Post Office Remodeling

Flad & Associates, Inc.

Project No. 78122

JUNE 20, 1979

Sheet No.
P.2

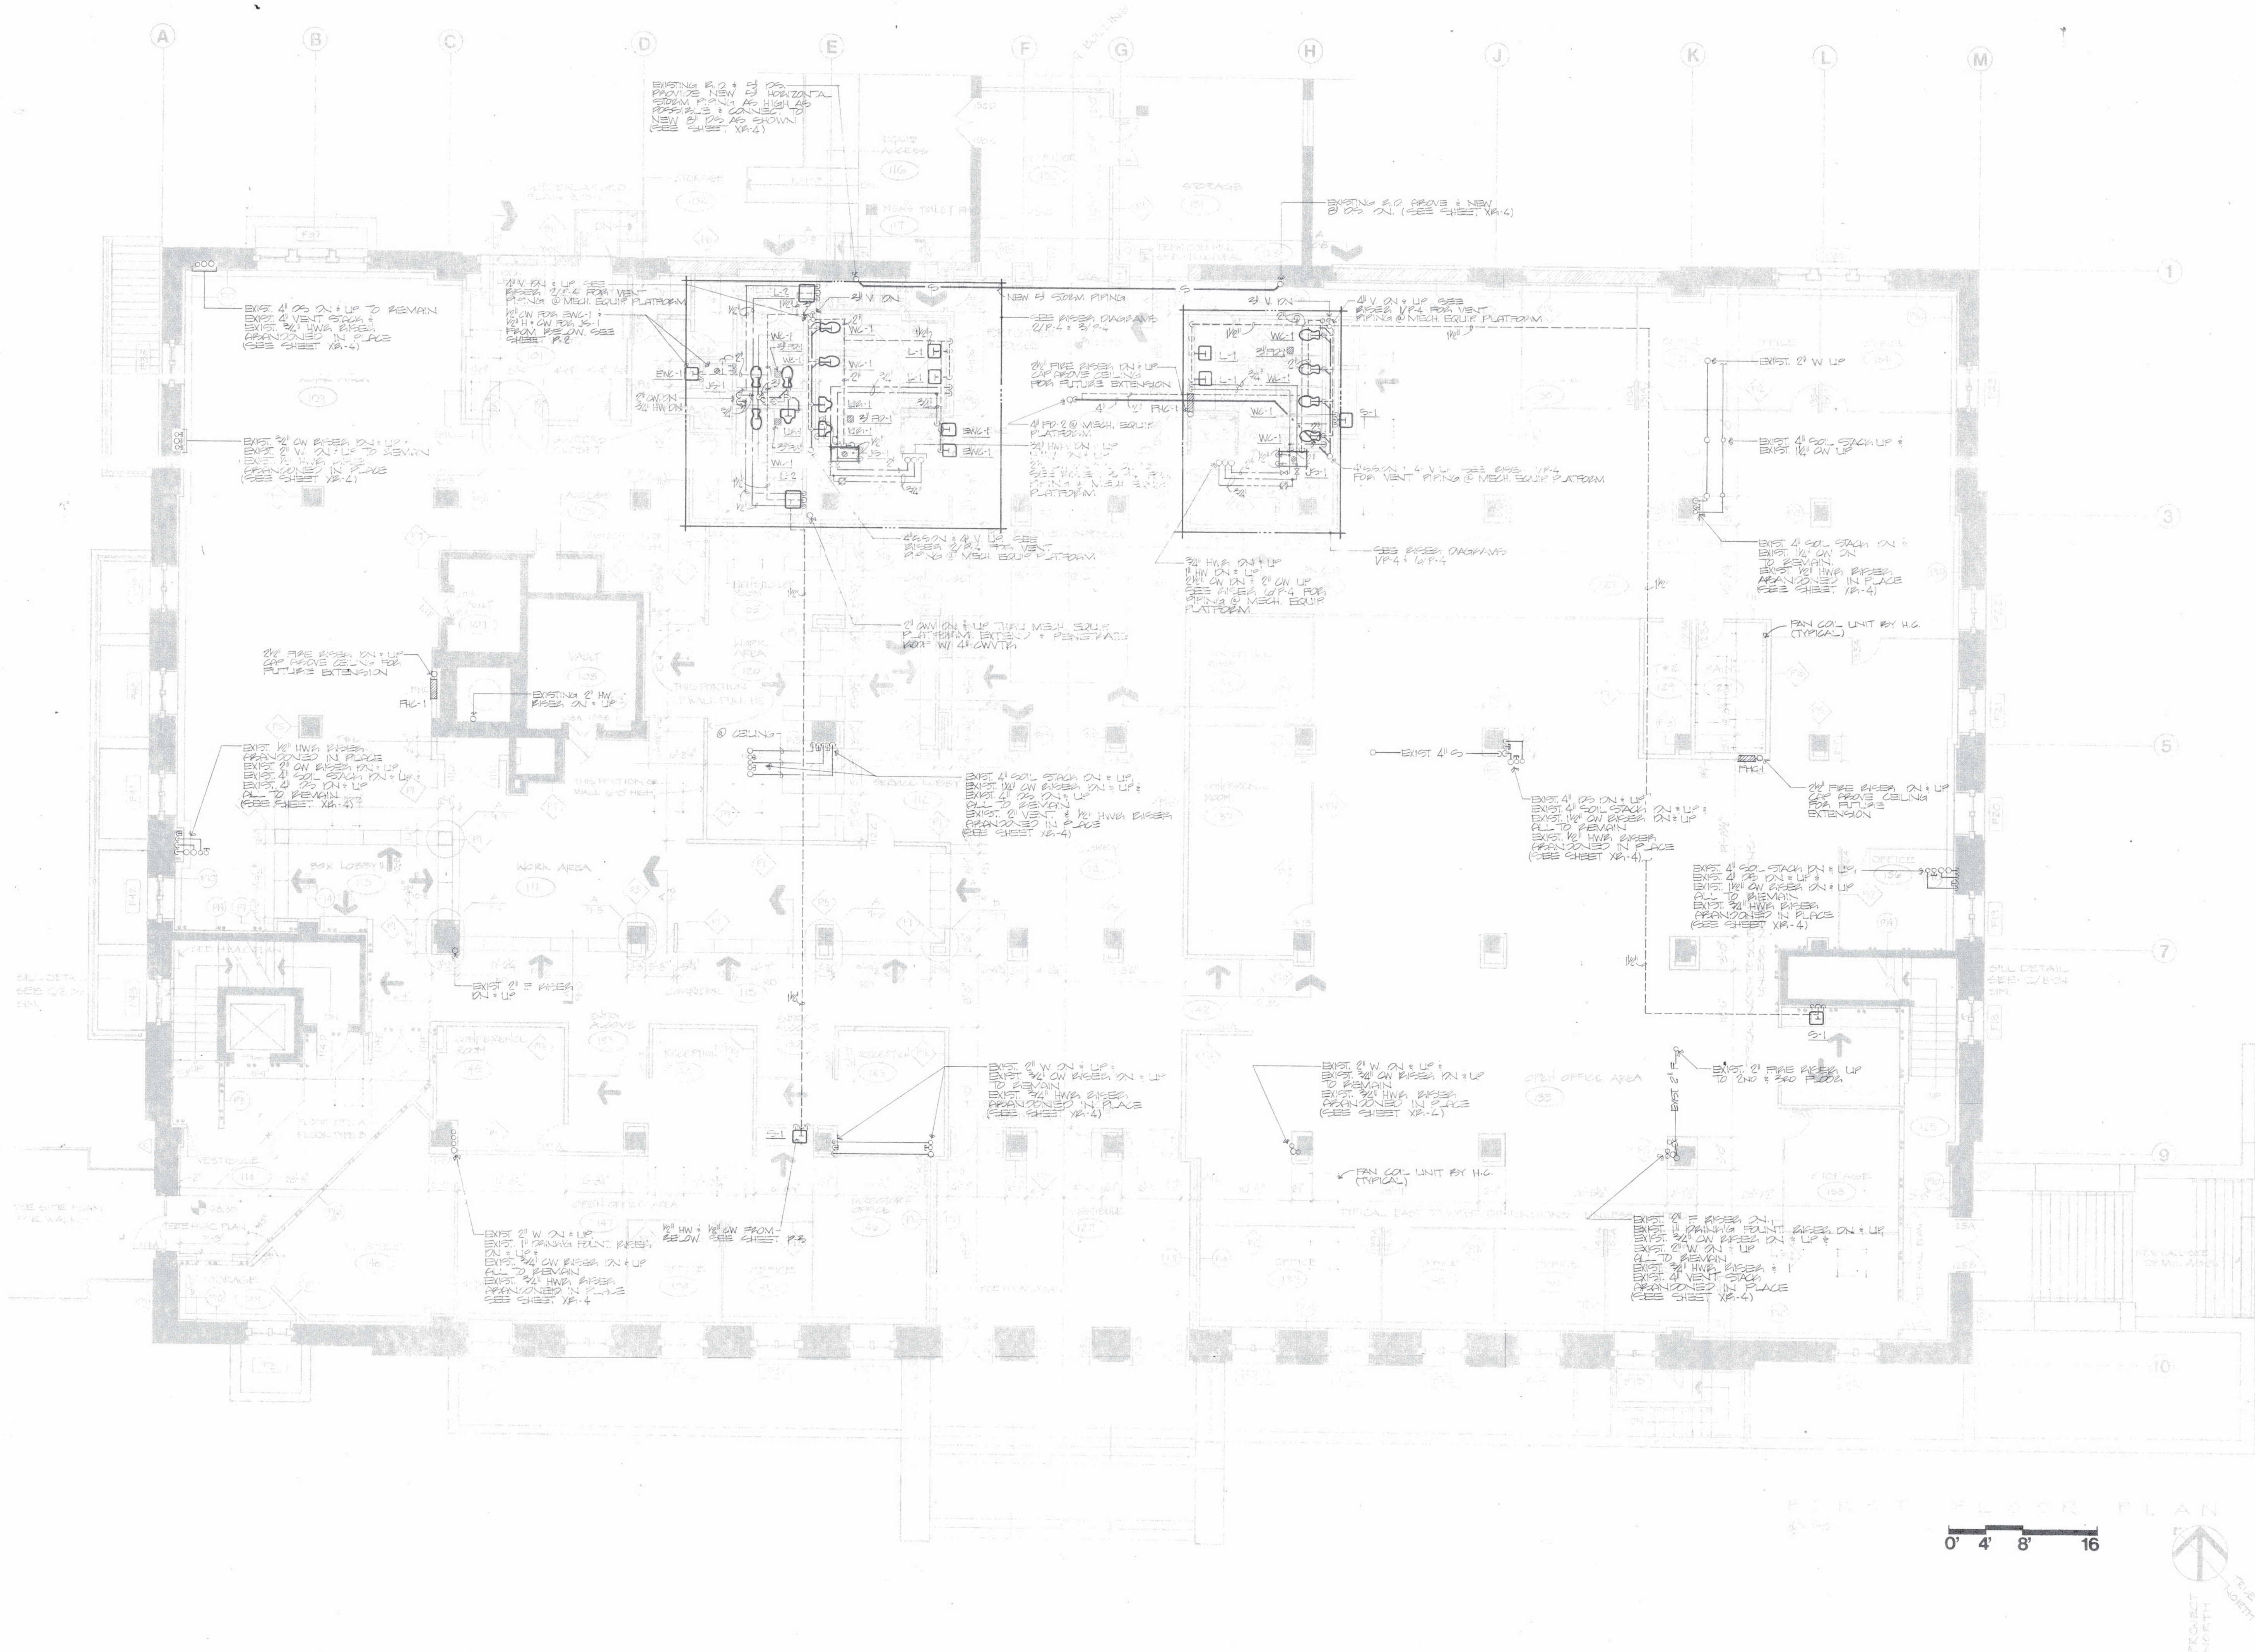
SHEET P-2
Room 024 & 034, delete water closet & lavatory and all associated waste, vent & water piping for these fixtures in each room.

E-2

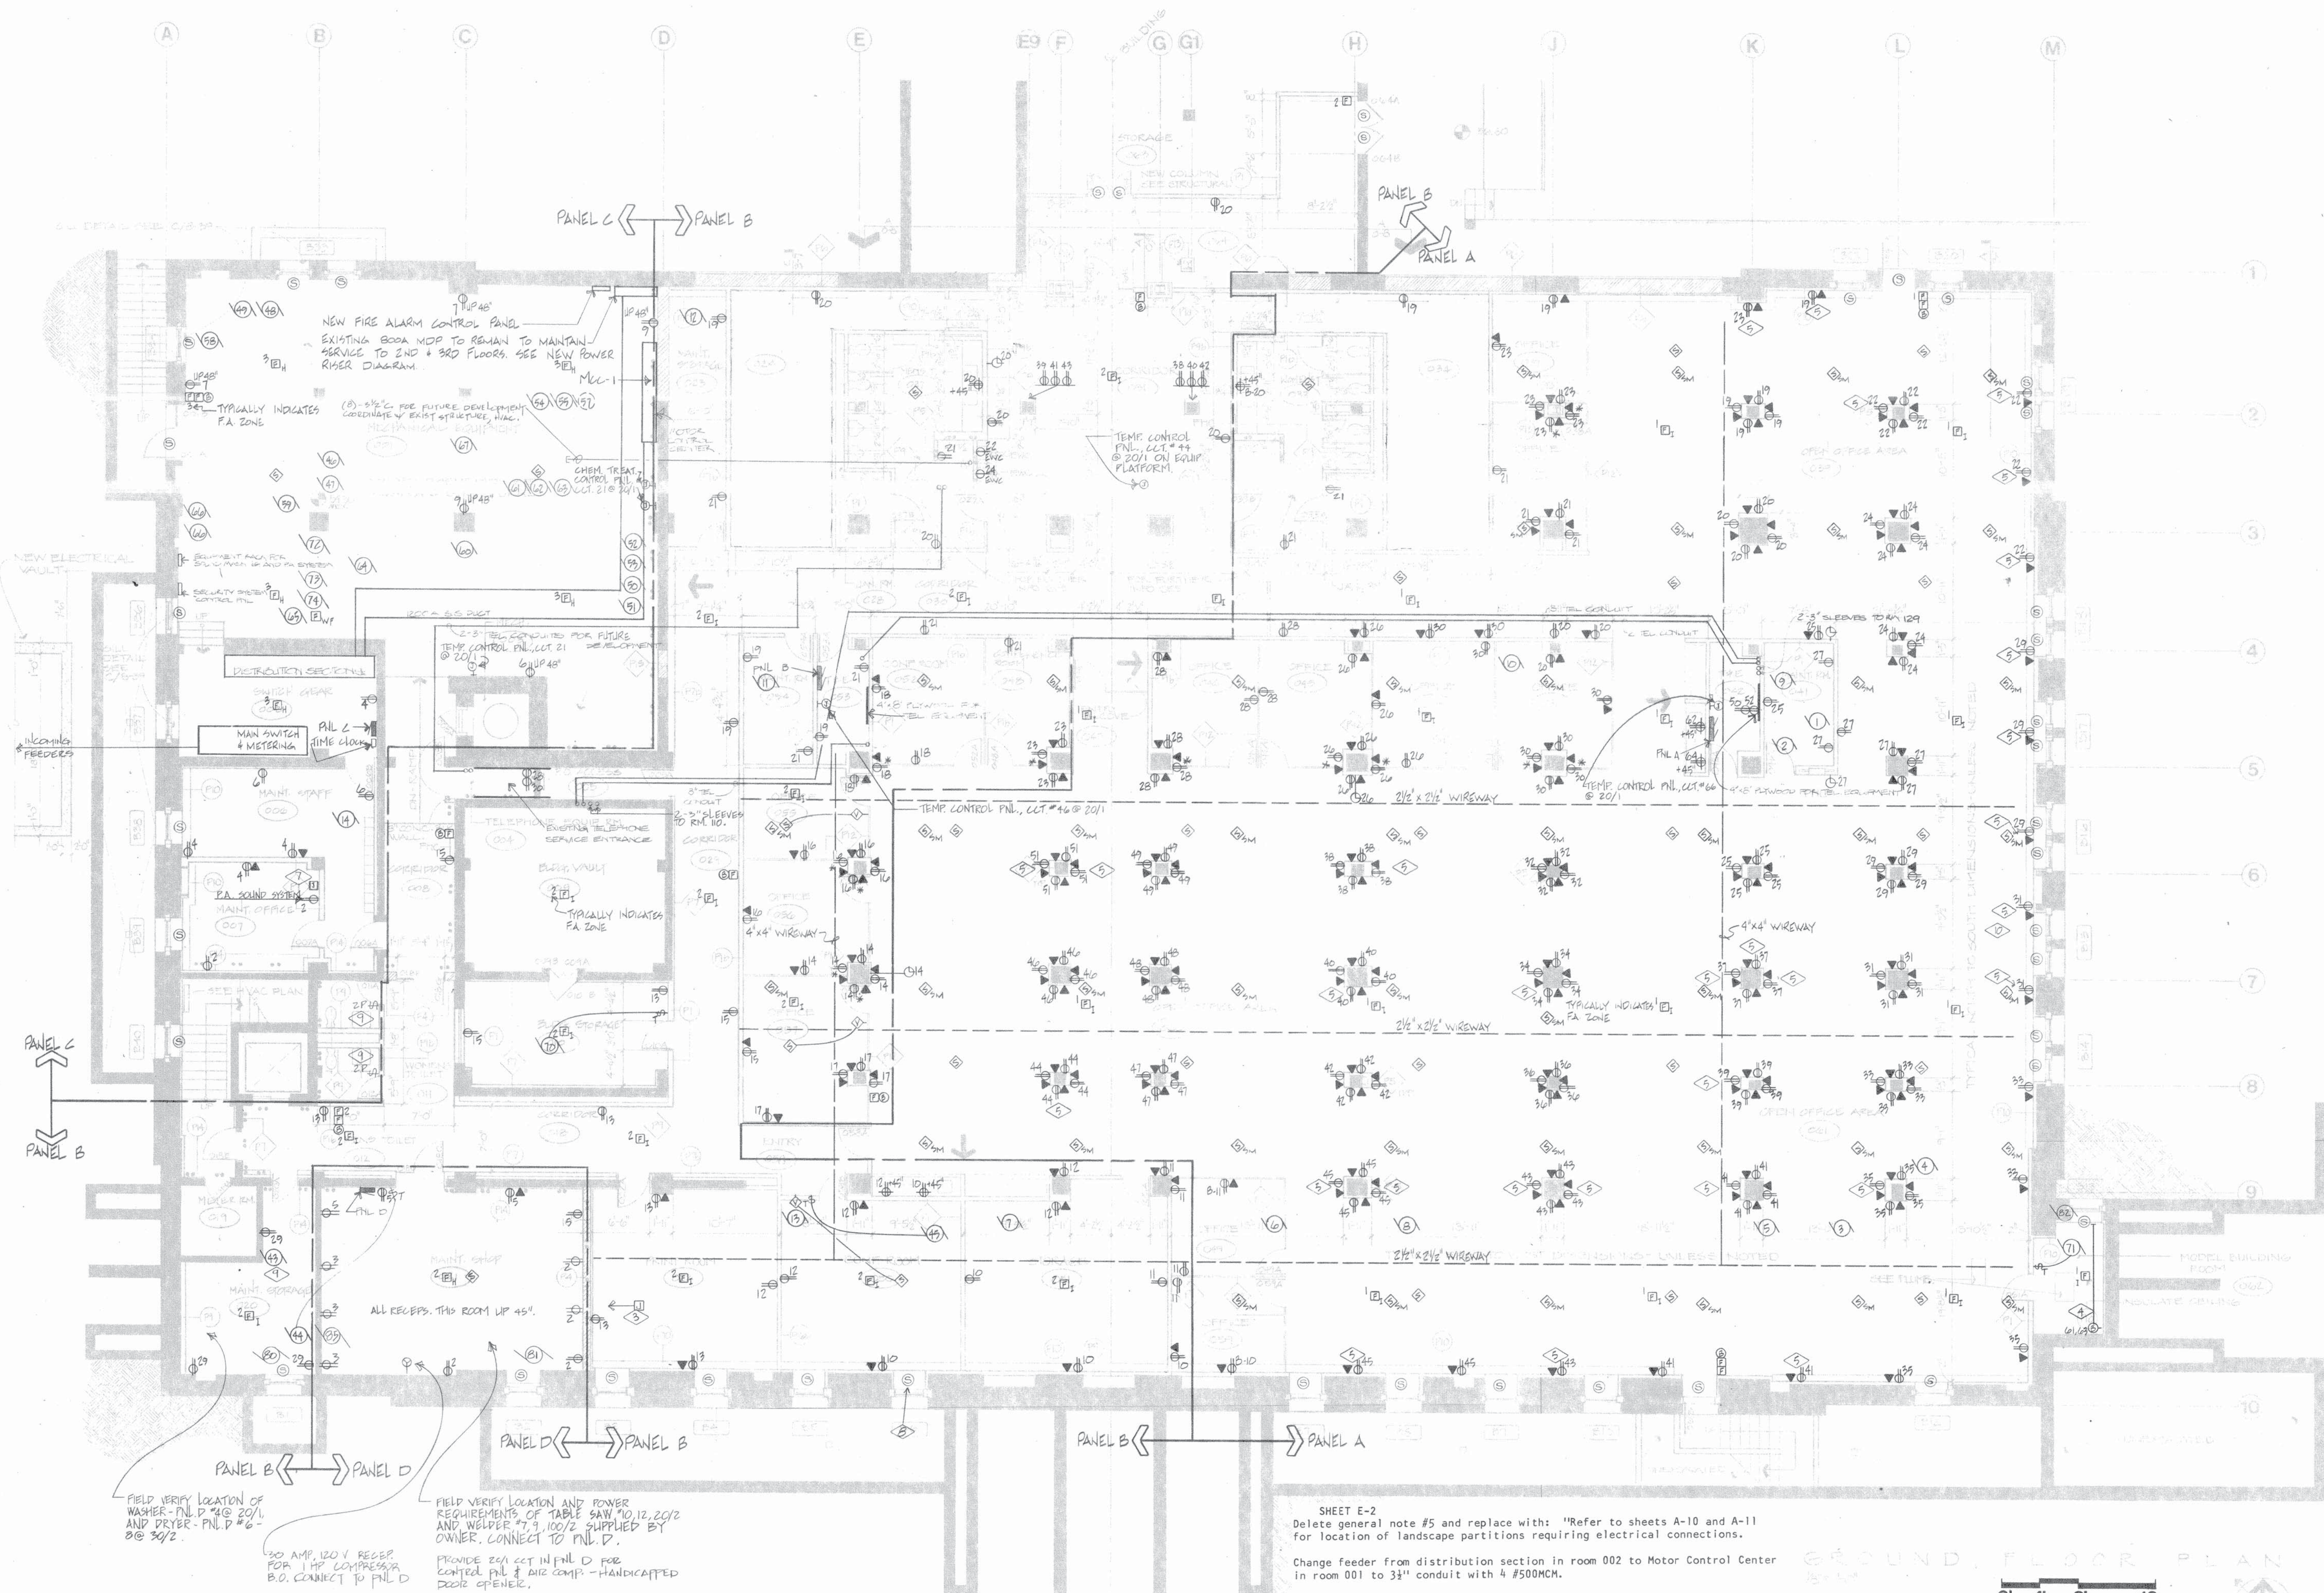
SHEET E-2
Delete general note #5 and replace with: "Refer to sheets A-10 and A-11 for location of landscape partitions requiring electrical connections."

Change feeder from distribution section in room 002 to Motor Control Center in room 001 to 3/4" conduit with 4 #500MCM.

SHEET E-2
Room 001: Extend (8)-3/4" C. for future development from room 001 into electrical distribution section, room 002.

Room 002: add, Security system "broken glass" detector to window, this room. Connect to security system.

SHEET E2 and E4
Wireway in ceiling space (2 1/2" x 2 1/2" and 4" x 4") is intended for telephone wiring. Provide conduit from telephone outlets to wireway per section 1651.

Sheet No.
E-4

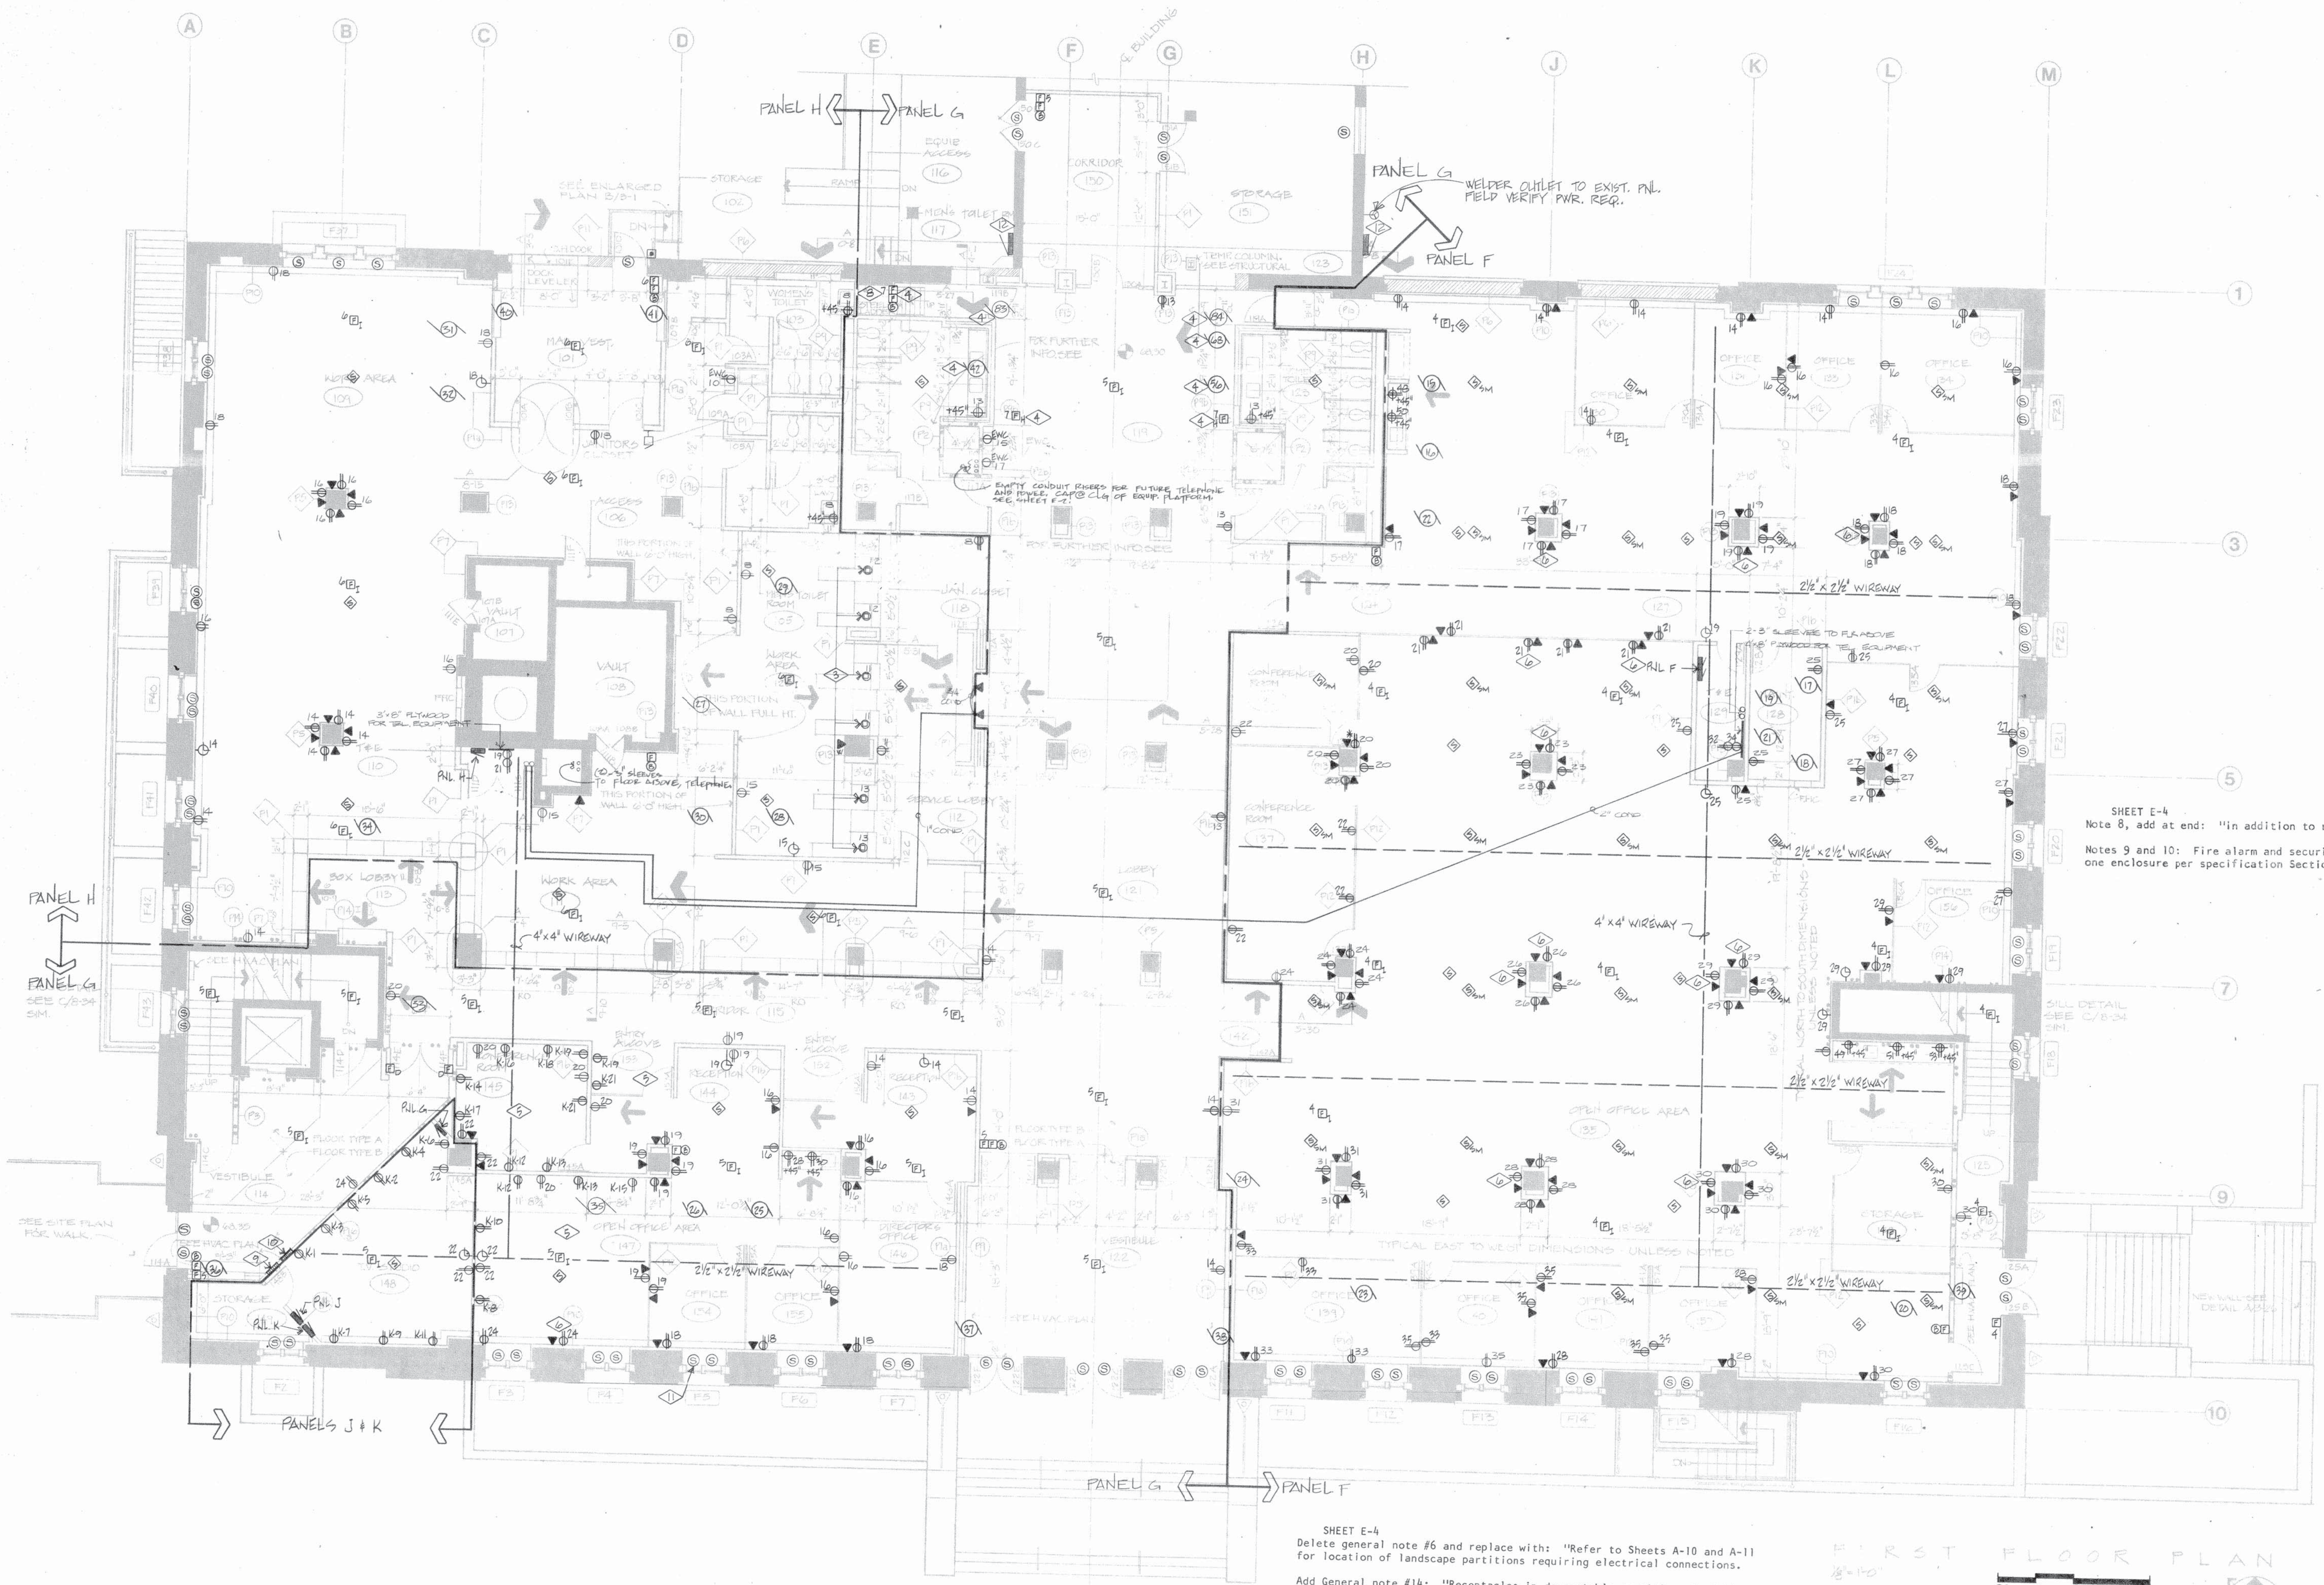
SHEET E-4
Note 8, add at end: "In addition to receptacles shown on Sheet HV-3."
Notes 9 and 10: Fire alarm and security alarm annunciator panels shall be in one enclosure per specification Section 1658.

SHEET E-4
Delete general note #6 and replace with: "Refer to Sheets A-10 and A-11 for location of landscape partitions requiring electrical connections."
Add General note #14: "Receptacles in demountable partitions in following rooms to be connected via the flexible electrical wiring system per specification Section 1615: Rooms 127, 130, 131, 133, 134, 136, 137, 135, 156, 158, 139, 140, 141, 157, 145, 144, 143, 146, 155, 154, 147. See detail 16-3."
